AGENDA

PLANNING & ZONING COMMISSION REGULAR MEETING WEDNESDAY, JANUARY 10, 2024 - 3:30 PM MCALLEN CITY HALL, 1300 HOUSTON AVENUE CITY COMMISSION CHAMBERS, 3RD FLOOR

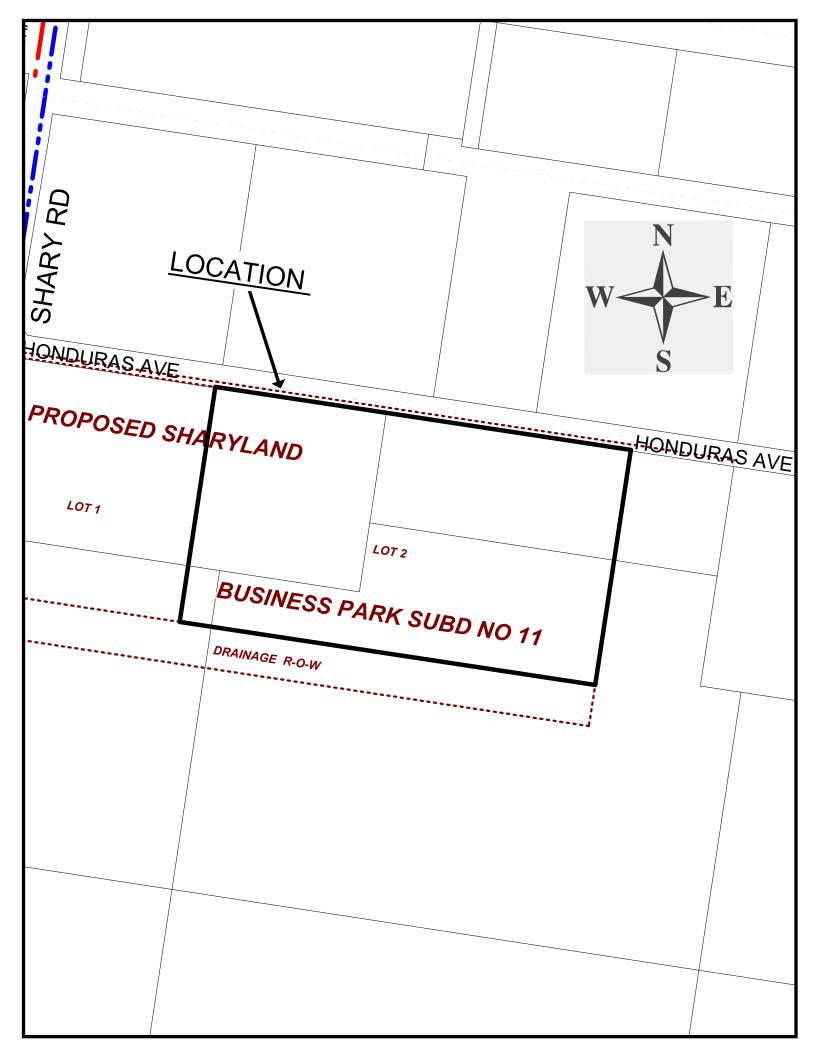
SUBDIVISION NAME: SHARYLAND BUSINESS PARK NO. 11			
REQUIREMENTS			
STREETS AND RIGHT-OF-WAYS			
 Honduras Ave: 80 ft. ROW dedication Paving: 52 ft. Curb & gutter: Both Sides Revisions needed: Submitted plat depicts 80 ft. existing ROW. Reference the document number for how the existing ROW has been dedicated and provide a copy for staff review prior to final. ** At the Planning and Zoning Commission meeting of April 5th,2022, the proposed subdivision to the north under the name of Sharyland Business park No. 10 received a variance to provide 44ft. of pavement width in lieu of 52ft with 80 ft. of ROW. ***ROW requirements must be finalized prior to final. ****Subdivision Ordinance: Section 134-105 *****Monies must be escrowed if improvements are required prior to recording 	Non-compliance		
Paving Curb & gutter **Subdivision Ordinance: Section 134-105 **Monies must be escrowed if improvements are required prior to final **COM Thoroughfare Plan	Applied

* 1,200 ft. Block Length - Subdivision layout does not comply with block length requirement. Please revise accordingly prior to final or submit a variance request. Any variance request must be approved prior to final. **Subdivision Ordinance: Section 134-118 	Non-compliance

* 900 ft. Block Length for R-3 Zone Districts **Subdivision Ordinance: Section 134-118	NA		
* 600 ft. Maximum Cul-de-Sac **Subdivision Ordinance: Section 134-105	NA		
ALLEYS			
 ROW: 20 ft. Paving: 16 ft. *Alley/service drive easement required for commercial properties. - Add the following plat note prior to final: A minimum 24 ft. private service drive ease easement will be established as part of the site plan and will be maintained by the lot owners and not the City of McAllen. ** The subdivision is a proposed replat of Lot 2, Sharyland Business Park No. 11 Subdivision; therefore, all originally recorded plat notes will apply. **Subdivision Ordinance: Section 134-106 	Non-compliance

SETBACKS	
 * Front: In accordance with zoning ordinance, or greater for easements or approved site plan, or in line with average setback, whichever is greater applies. Revisions needed: Revise plat note No.2 as shown above prior to final. **Zoning Ordinance: Section 138-356 & 138-367 ** The subdivision is a proposed replat of Lot 2, Sharyland Business Park No. 11 Subdivision; therefore, all originally recorded plat notes will apply. 	Non-compliance

* Rear: In accordance with zoning ordinance, or greater for easements or approved site plan, whichever is greater applies. Revisions needed: Revise plat note No.2 as shown above prior to final. **Zoning Ordinance: Section 138-356 ** The subdivision is a proposed replat of Lot 2, Sharyland Business Park No. 11 Subdivision; therefore, all originally recorded plat notes will apply. 	Non-compliance

* Sides: In accordance with zoning ordinance, or greater for easements or approved site plan, or in line with average setback, whichever is greater applies. Revisions needed: Revise plat note No.2 as shown above prior to final. **Zoning Ordinance: Section 138-356 ** The subdivision is a proposed replat of Lot 2, Sharyland Business Park No. 11 Subdivision; therefore, all originally recorded plat notes will apply. **Zoning Ordinance: Section 138-356 	Non-compliance

* 5 ft. wide minimum sidewalk required along Honduras Avenue. - Add a plat note as shown above prior to final. **Subdivision Ordinance: Section 134-120 ** The subdivision is a proposed replat of Lot 2, Sharyland Business Park No. 11 Subdivision; therefore, all originally recorded plat notes will apply. 	Non-compliance

* Perimeter sidewalks must be built or money escrowed if not built at this time.	Applied
BUFFERS	
 * 6 ft. opaque buffer required from adjacent/between multi-family residential and commercial, and industrial zones/uses. - Add a plat note as shown above prior to final. ** The subdivision is a proposed replat of Lot 2, Sharyland Business Park No. 11 Subdivision; therefore, all originally recorded plat notes will apply. **Landscaping Ordinance: Section 110-46 	Non-compliance

* 8 ft. masonry wall required between single family residential and commercial, industrial, or multi-family residential zones/uses - Add a plat note as shown above prior to final. ** The subdivision is a proposed replat of Lot 2, Sharyland Business Park No. 11 Subdivision; therefore, all originally recorded plat notes will apply. **Landscaping Ordinance: Section 110-46 	Non-compliance

* Common Areas, and service drives must be maintained by the lot owners and not the City of McAllen.	Non-compliance
 Add a plat note as shown above prior to final. ** The subdivision is a proposed replat of Lot 2, Sharyland Business Park No. 11 Subdivision; therefore, all originally recorded plat notes will apply

TRAFFIC	
* As per Traffic Department, Trip Generation required to determine if TIA is required, prior to final plat.	Required
* Traffic Impact Analysis (TIA) required prior to final plat.	TBD
COMMENTS	
 Comments: Rename the subdivision name to: Sharyland Business Park No. 11A Subdivision prior to final. Rename the lot numbers to 2A, 2B, and 2C prior to final. There is a discrepancy between the dimensions of Lot 2 as shown on Sharyland Business Park No. 11 Subdivision and the proposed plat. Please clarify prior to final. Provide the legal description of all adjacent lots on all sides, including the lots on the east side of the subdivision and north side of Honduras Avenue, prior to final. Recorded plat notes remain effective. Please add all relevant plat notes from Sharyland Business Park No. 11 prior to final. If any plat note is proposed to be removed or altered, a vacate and replat is required. All signature blocks must comply with Section 134-61 of the subdivision ordinance prior to recording. * Must comply with City's Access Management Policy. ** The subdivision is a proposed replat of Lot 2, Sharyland Business Park No. 11 Subdivision; therefore, all originally recorded plat notes will apply. 	Non-compliance

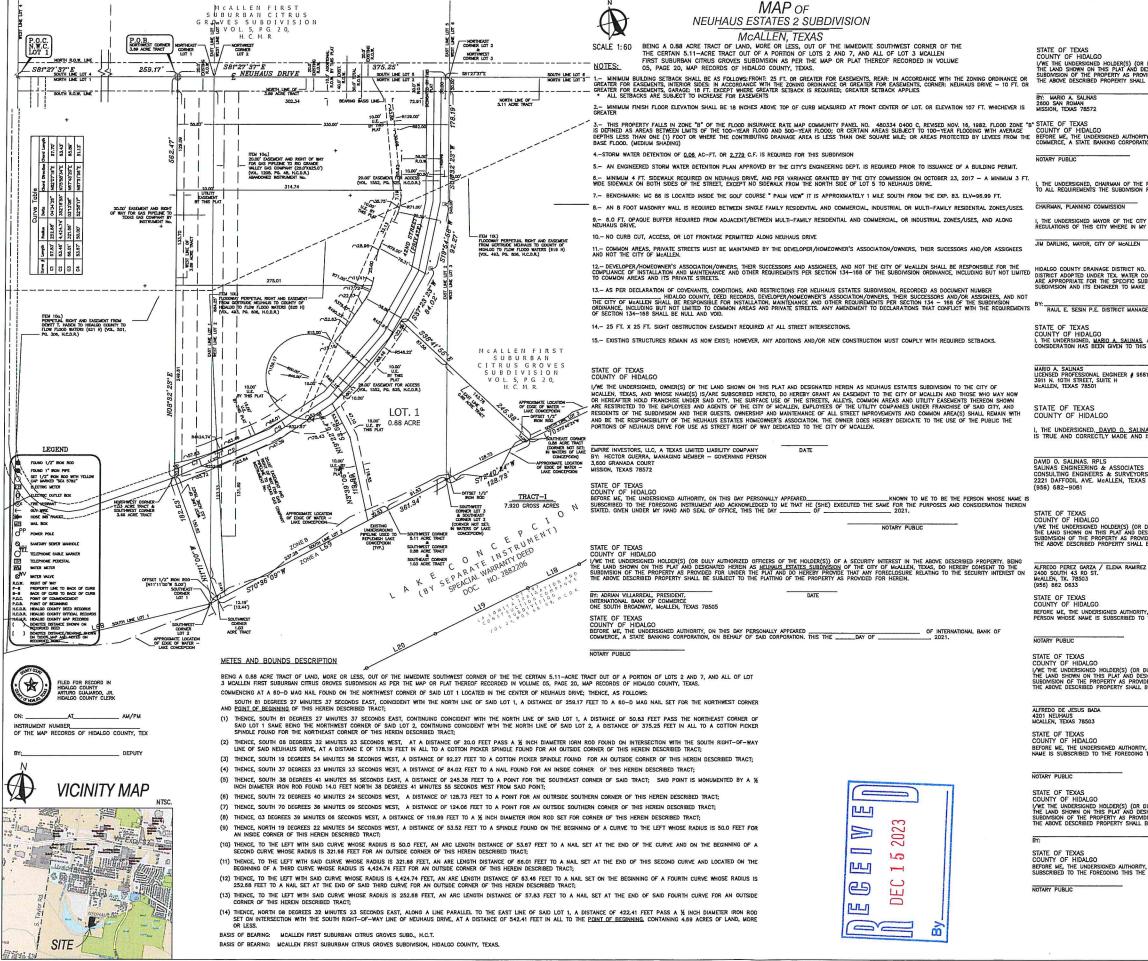
SUBDIVISION NAME: NEUHAUS ESTATES II SUBDIVISION	
REQUIREMENTS	
STREETS AND RIGHT-OF-WAYS	
 S. 42nd Street (private): 56-76.31 ft. ROW proposed Paving: min. 32 ft. Curb & gutter: both sides Revisions needed: Revise the street name to "S. 42nd Street" prior to final. Neuhaus Estates Subdivision must be recorded prior to final as Neuhaus Estates II is currently landlocked. Reference the document number as how the ROW has been dedicated prior to final. An agreement between the private street owner(s) and proposed subdivision will be required prior to final as Neuhaus Estates II is currently landlocked 	Non-compliance
Neuhaus Estates Subdivision's project engineer requested a variance on behalf of the developer to allow one-20 ft. entrance and one-14 ft. wide exit lane with a 10 ft. median with existing trees instead of the 32 ft. cross section as required for single family residential development. City Commission granted a variance to allow a 20 ft. entrance and 17 ft. wide exit with no sidewalks on the east side at their meeting on October 23, 2017. *Improvements must be escrowed if not built prior to recording. ***Cul-de-sac must be 96 ft. paving diameter face-face according to fire department requirements.

Corner (Proposing): Neuhaus Drive: 10 ft. or greater for easements Remove the proposed note prior to final, as the property does not front Neuhaus Drive. **Zoning Ordinance: Section 138-356 	Non-compliance

* Garage: 18 ft. except where greater setback is required, greater setback applies **Zoning Ordinance: Section 138-356	Applied
*ALL SETBACKS ARE SUBJECT TO INCREASE FOR EASEMENTS OR APPROVED SITE PLAN	Non-compliance

- Remove the wording above from plat note #1 prior to final since it is not a required plat note.	
SIDEWALKS	
 * 4 ft. wide minimum sidewalk required on S. 42nd Street Revise plat note #6 as shown above prior to final. Proposing: Minimum 4 ft. wide minimum sidewalk required on Neuhaus Drive and per variance granted by the City Commission on October 23, 2017, a minimum 3 ft. wide sidewalk on both sides of the street, except no sidewalk from the north side of Lot to Neuhaus Drive. * The property does not front Neuhaus Drive. ** Neuhaus Estates Subdivision's project engineer requested a variance, on behalf of the developer, for a 3 ft. wide sidewalk on the east side of S. 42nd Street due to the existing trees and property line. City Commission granted a variance to allow a 20 ft. entrance and 17 ft. wide exit with no sidewalks on the east side of S. 42nd Street from the north of Lot 1, Neuhaus Estates II Subdivision (formerly being Lot 5, Neuhaus Estates Subdivision and submitted as Neuhaus Estates II Subdivision. Therefore, sidewalk requirement will apply to this subdivision. 	Non-compliance

* Perimeter sidewalks must be built or money escrowed if not built at this time.	Applied
BUFFERS	
 * 6 ft. opaque buffer required from adjacent/between multi-family residential and commercial, and industrial zones/uses Revise the plat note as shown above prior to final. Proposing: ft. opaque buffer required from adjacent/between multi-family residential and commercial, and industrial zones/uses and along Neuhaus Drive. The property does note front Neuhaus Drive. **Landscaping Ordinance: Section 110-46 * 8 ft. masonry wall required between single family residential and commercial, industrial, or multi-family residential zones/uses **Landscaping Ordinance: Section 110-46 	Non-compliance Applied
*Perimeter buffers must be built at time of Subdivision Improvements.	Applied
NOTES	
Proposing: No curb cut, access, or lot frontage permitted along Neuhaus Drive. - Remove plat note #10 since the property does not front Neuhaus Drive. **Must comply with City Access Management Policy	Non-compliance
